Inspection Report

| Inspection Date: | Thursday, September 2, 2021 |

Permittee: **EMERY COUNTY COAL RESOURCES, INC.**
 Operator: **EMERY COUNTY COAL RESOURCES, INC.**
 Site: **LILA CANYON MINE**
 Address: **PO BOX 910, EAST CARBON UT 84520-0910**
 County: **CARBON**
 Permit Type: **PERMANENT COAL PROGRAM**
 Permit Status: **ACTIVE**

ATTACHMENT A – Lila Canyon

PHOTO 3
Sediment Pond #2

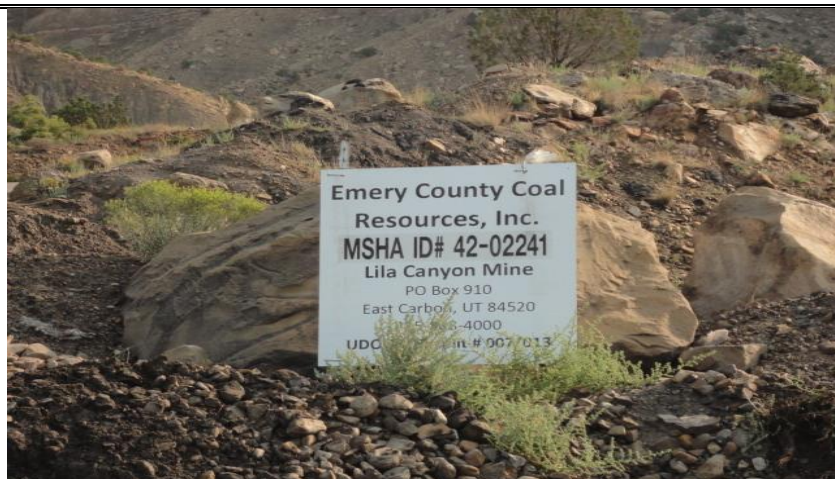
I inspected both sediment ponds. Both contain some water from recent rainstorms in August. Sediment pond #2 needs repair work to the inner embankments of the pond. Erosion has occurred due to rainstorms. The pond is incised and therefore no hazardous condition existed. Water could enter the pond that it is not designed to do.
